Engineering Assessment Report

Proposed Residential Development Site at Knockrabo Phase 2,
Mount Anville Road, Goatstown, Dublin

Client Name: Knockrabo Investments DAC
Document Reference: 20-086r.001 Engineering Assessment Report
Project Number: 20-086

Figure 6.3 – Compromised Pedestrian / Motorist Invisibility

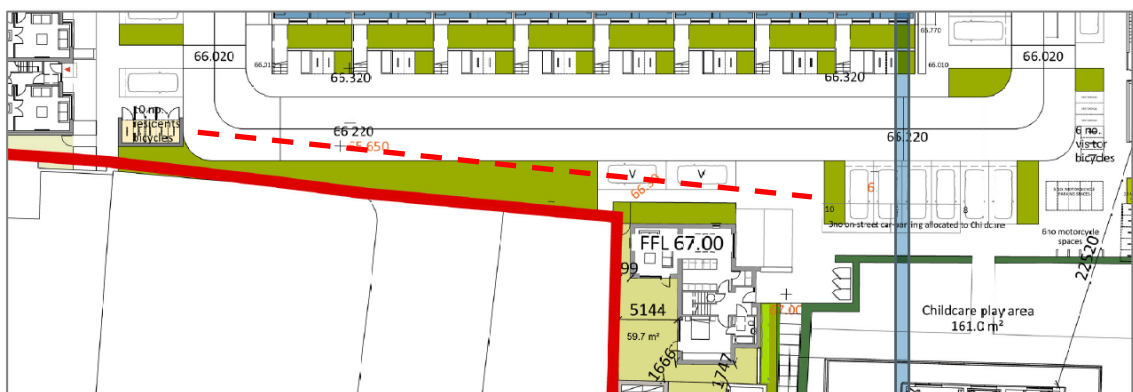
The pedestrian desire lines shown in Figure 6.3 will not be met by infrastructure and pedestrians will either walk along the roadway or have to cross the roadway twice in some locations.

Figure 7.1 – GDA Cycle Network (www.nationaltransport.ie/wp-content/uploads/2023/01/2022-GDA-Cycle-Network.pdf)

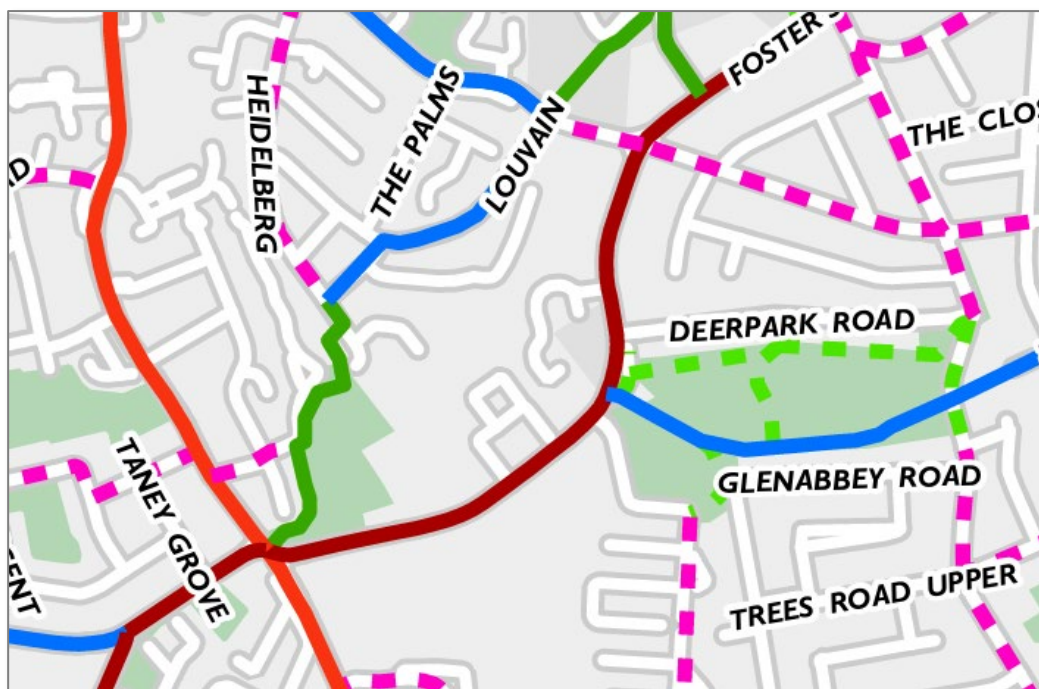
As there is no proposed cycle infrastructure in the development, it is not clear how the development will tie into the proposed 'Primary Orbital' Route (Maroon in Figure 7.1) or 'Secondary' (Blue in Figure 7.1) adjacent or within the development. A lack of coordination may reduce the effectiveness of these schemes and undermine potential to achieve cyclist desire lines.

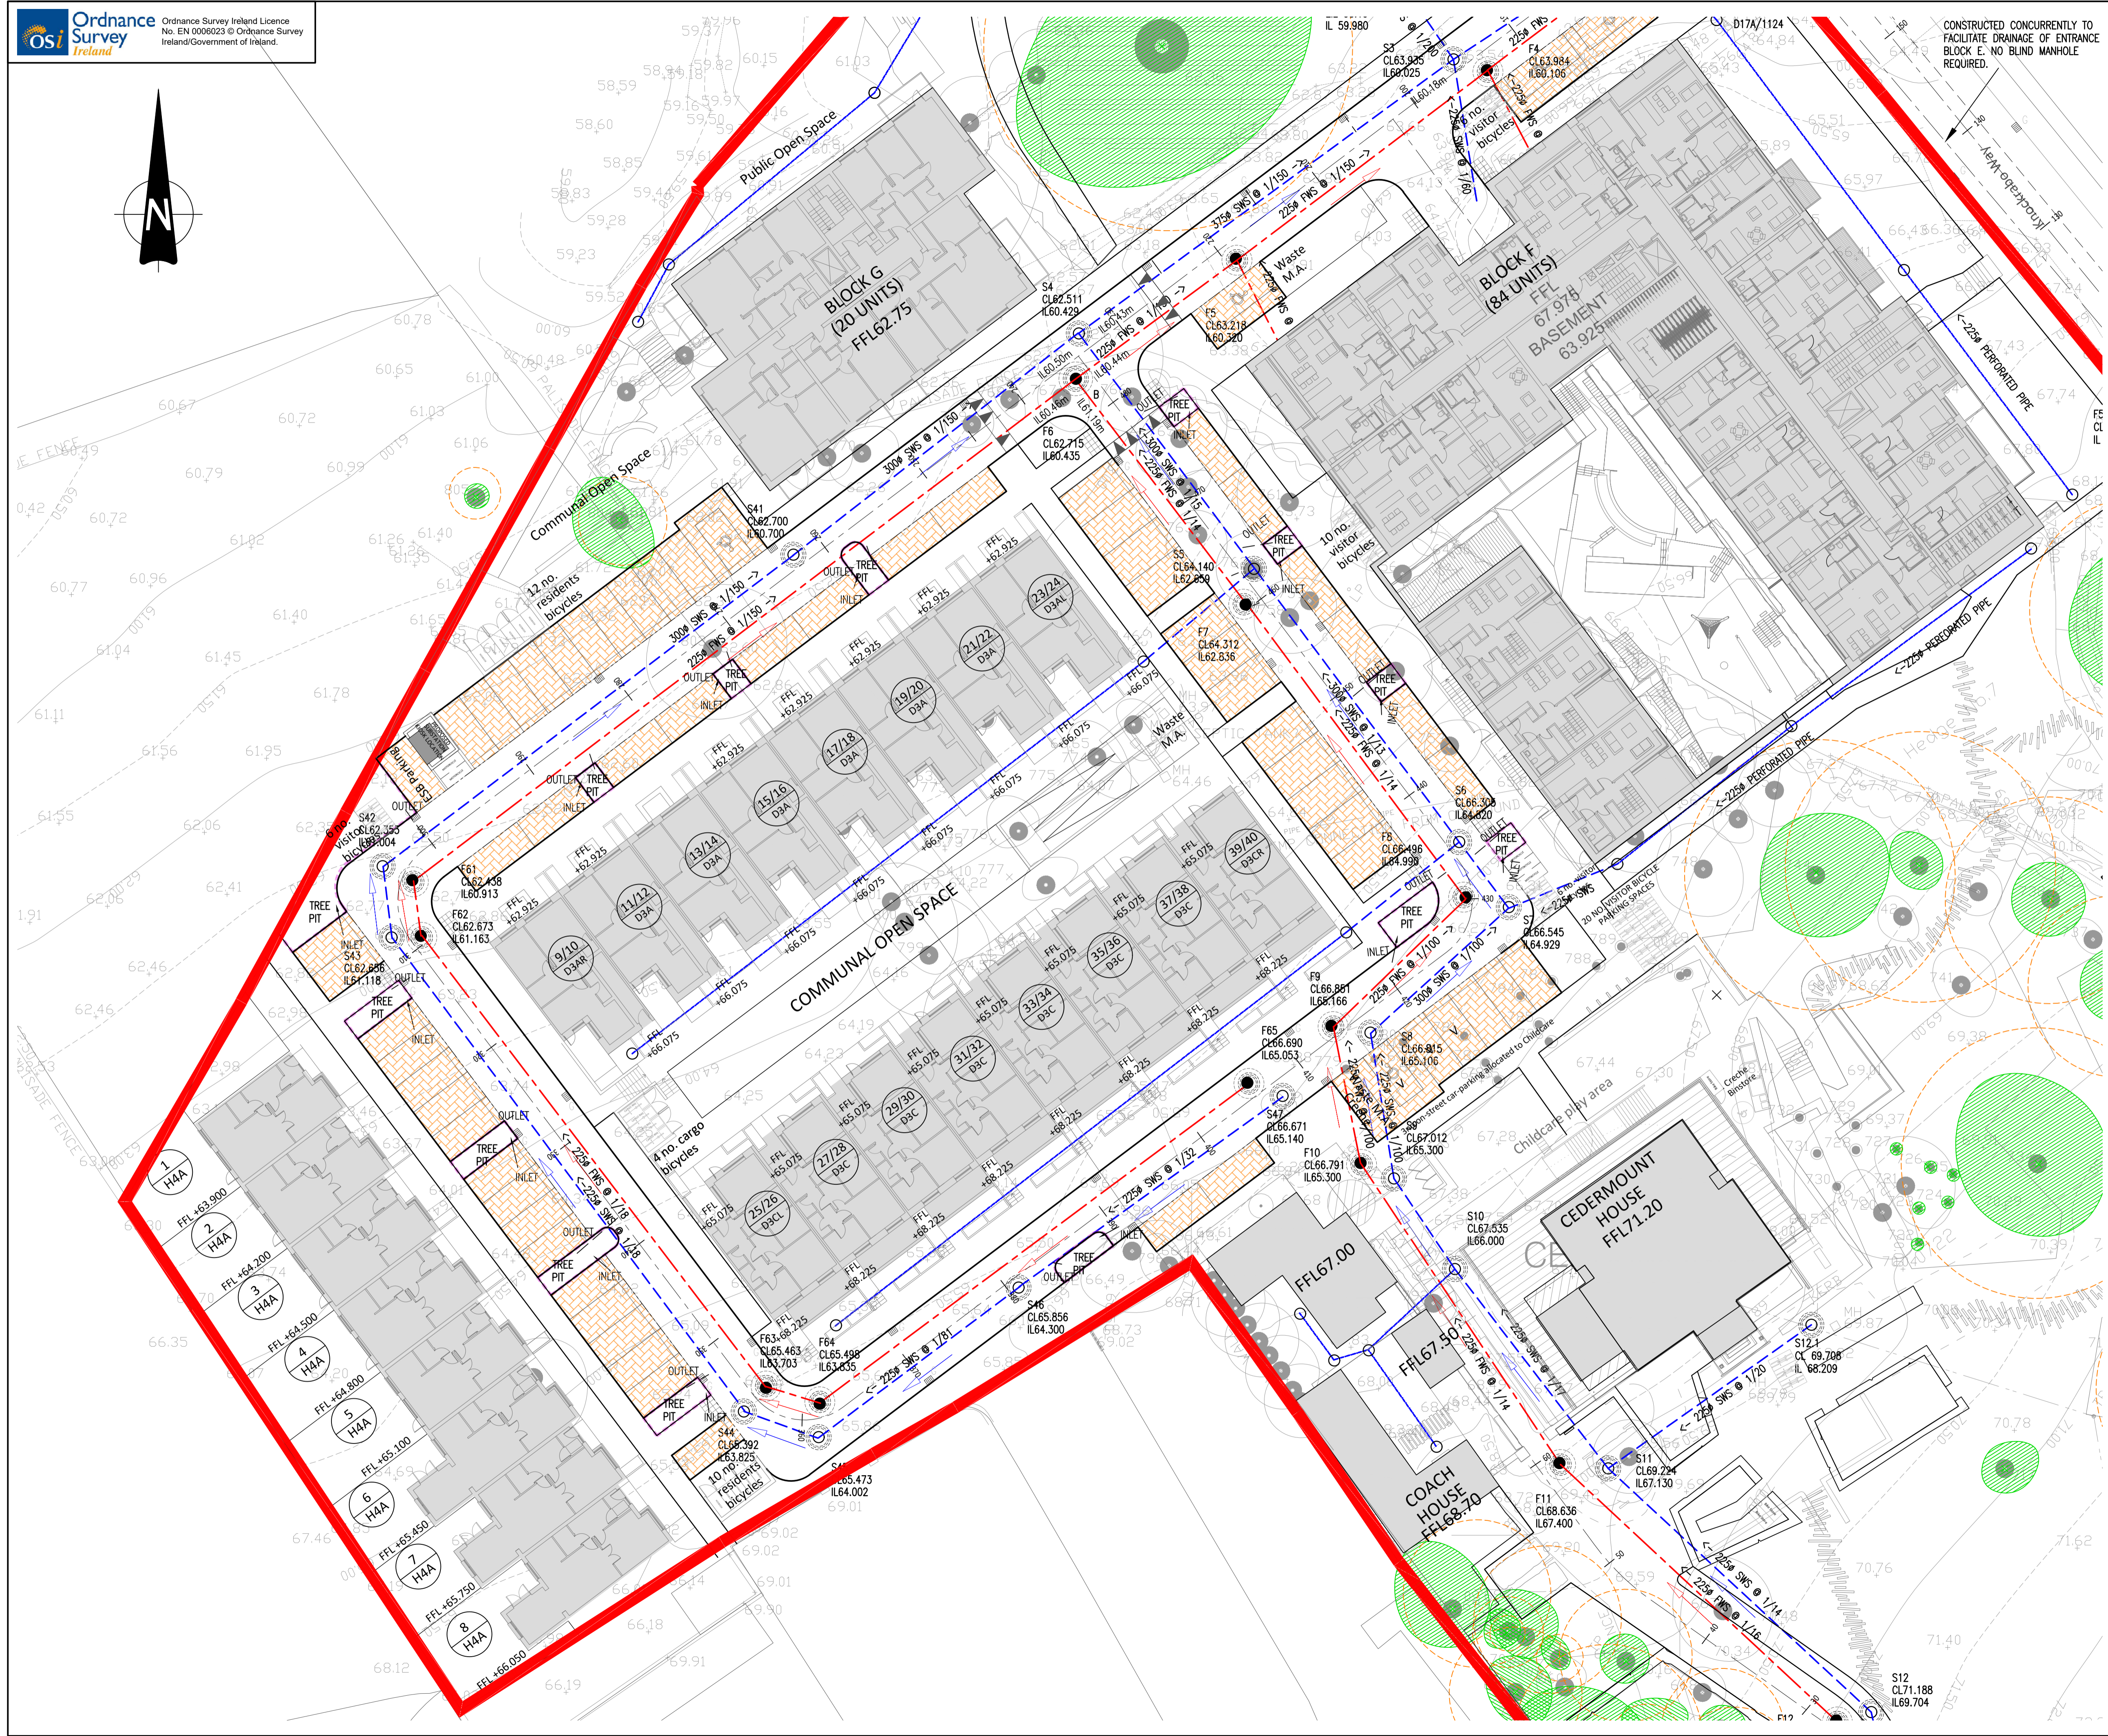
5	Gate Lodge West appears to have a soakaway, but no details are provided.	WM to clarify	Gate Lodge West has now been positively drained to the SW network as per updated drainage drawing 20-086-P121 Drainage Layout, as all infiltration test on this site failed.	See Note 17
6	The head/discharge relationship for the hydrobrake isn't provided.	WM to provide	We have since carried out a Flow Model which has resulted in an outflow rate of 14.7 l/s and a head of 1.2m for the hydrobrake.	See Note 17
7	SAAR value as per engineering report is 881mm. However, Appendix D calculations use SAAR value 774mm.	WM to clarify SAAR value used	Please refer to updated 20-086 Engineering Assessment Report, which now has a SAAR of 836mm - Met Éireann (2024) in the body of the report and Appendix D calculations.	See Note 17
8	20% Climate change factor considered in calculations by WM. 10% Urban Creep factor is required as per DLRCC's County Development Plan 2022-2028.	WM to confirm whether urban creep has been accounted for.	Urban creep 10% has been accounted in the drainage design for private houses an duplexes.	See Note 20
